The Shoreline Partnership
Alterations to Shoreline GA01
Lands at Baldoye

QUALITY AUDIT

BD-CSC-ZZ-XX-DR-C-0034

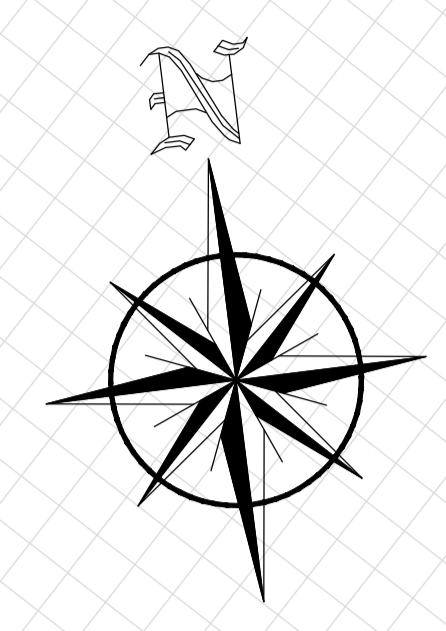
(QA - 414)
IN RESPONSE TO ITEM 4.14 OF THE QUALITY AUDIT,
DROPPED KERBS & TACTILE PAVING PROVIDED

(QA - 411)
IN RESPONSE TO ITEM 4.11 OF THE QUALITY AUDIT,
ROAD MARKINGS AND TRAFFIC SIGNS PROVIDED
TO ENFORCE THE ONE WAY SYSTEM

(QA - 4.7)
IN RESPONSE TO ITEM 4.7 OF THE QUALITY AUDIT,
RAISED TABLE PROVIDED TO REDUCE SPEED

(QA - 4.13)
IN RESPONSE TO ITEM 4.13 OF THE QUALITY AUDIT,
BUS STOP RELOCATED TO IMPROVE PEDESTRIAN CROSSING VISIBILITY

(QA - 4.12)
IN RESPONSE TO ITEM 4.12 OF THE QUALITY AUDIT,
ONE WAY ROAD RESTRICTION

(QA - 4.25)
IN RESPONSE TO ITEM 4.25 OF THE QUALITY AUDIT,
PEDESTRIAN ACCESS PROVIDED TO THE NORTHERN
HALF OF THE CARPARK

(QA - 4.27)
IN RESPONSE TO ITEM 4.27 OF THE QUALITY AUDIT,
RAISED TABLE PROVIDED TO REDUCE SPEED

(QA - 4.22)
IN RESPONSE TO ITEM 4.22 OF THE QUALITY AUDIT,
ASLE WIDTH INCREASED

(QA - 4.24)
IN RESPONSE TO ITEM 4.24 OF THE QUALITY AUDIT,
PEDESTRIAN ACCESS PROVIDED FROM STAPOLIN SQUARE
TO UNDERCROFT CARPARK

(QA - 4.23)
IN RESPONSE TO ITEM 4.23 OF THE QUALITY AUDIT,
ROAD MARKINGS PROVIDED AT ALL JUNCTIONS
WITHIN CARPARK TO INDICATE PRIORITY

(QA - 4.16)
IN RESPONSE TO ITEM 4.16 OF THE QUALITY AUDIT,
PUBLIC LIFT PROVIDED TO ONE ACCESS TO TRAIN STATION

(QA - 4.24)
IN RESPONSE TO ITEM 4.24 OF THE QUALITY AUDIT,
PEDESTRIAN ACCESS PROVIDED FROM STAPOLIN SQUARE
TO UNDERCROFT CARPARK

(QA - 4.15)
IN RESPONSE TO ITEM 4.15 OF THE QUALITY AUDIT,
DROPPED KERBS & TACTILE PAVING PROVIDED

(QA - 4.7)
IN RESPONSE TO ITEM 4.7 OF THE QUALITY AUDIT,
RAISED TABLE PROVIDED TO REDUCE SPEED

(QA - 4.7)
IN RESPONSE TO ITEM 4.7 OF THE QUALITY AUDIT,
RAISED TABLE PROVIDED TO REDUCE SPEED

(QA - 4.10)
IN RESPONSE TO ITEM 4.10 OF THE QUALITY AUDIT,
JUNCTION PRIORITY REDESIGNED

(QA - 4.7)
IN RESPONSE TO ITEM 4.7 OF THE QUALITY AUDIT,
RAISED TABLE PROVIDED TO REDUCE SPEED

(QA - 4.10)
IN RESPONSE TO ITEM 4.10 OF THE QUALITY AUDIT,
YIELD MARKING & SIGN REMOVED

(QA - 4.15)
IN RESPONSE TO ITEM 4.15 OF THE QUALITY AUDIT,
DROPPED KERBS & TACTILE PAVING PROVIDED

(QA - 4.7)
IN RESPONSE TO ITEM 4.7 OF THE QUALITY AUDIT,
RAISED TABLE PROVIDED TO REDUCE SPEED

(QA - 4.9)
IN RESPONSE TO ITEM 4.9 OF THE QUALITY AUDIT,
STOP SIGN AND ROAD MARKINGS PROVIDED

(QA - 4.19)
IN RESPONSE TO ITEM 4.19 OF THE QUALITY AUDIT,
LINK ROAD DESIGN IN ACCORDANCE TO CAJMS

(QA - 4.20)
IN RESPONSE TO ITEM 4.20 OF THE QUALITY AUDIT,
SWEEP PATH ANALYSIS DOUBLE DECKER BUSES SHU. BY SIDE

(QA - 4.7)
IN RESPONSE TO ITEM 4.7 OF THE QUALITY AUDIT,
RAISED TABLE PROVIDED TO REDUCE SPEED

(QA - 4.6)
IN RESPONSE TO ITEM 4.6 OF THE QUALITY AUDIT,
DROPPED KERBS & TACTILE PAVING PROVIDED

(QA - 4.3)
IN RESPONSE TO ITEM 4.3 OF THE QUALITY AUDIT,
VISIBILITY SPLASH IN ACCORDANCE WITH DWMS

(QA - 4.4)
IN RESPONSE TO ITEM 4.4 OF THE QUALITY AUDIT,
DROPPED KERBS & TACTILE PAVING PROVIDED

(QA - 4.21)
IN RESPONSE TO ITEM 4.21 OF THE QUALITY AUDIT,
EXISTING CARRIAGEWAY WITH ACCOMMODATES PARKING MOVEMENTS

(QA - 4.2)
IN RESPONSE TO ITEM 4.2 OF THE QUALITY AUDIT,
DROPPED KERBS & TACTILE PAVING PROVIDED

(QA - 4.1)
IN RESPONSE TO ITEM 4.1 OF THE QUALITY AUDIT,
DROPPED KERBS & TACTILE PAVING PROVIDED
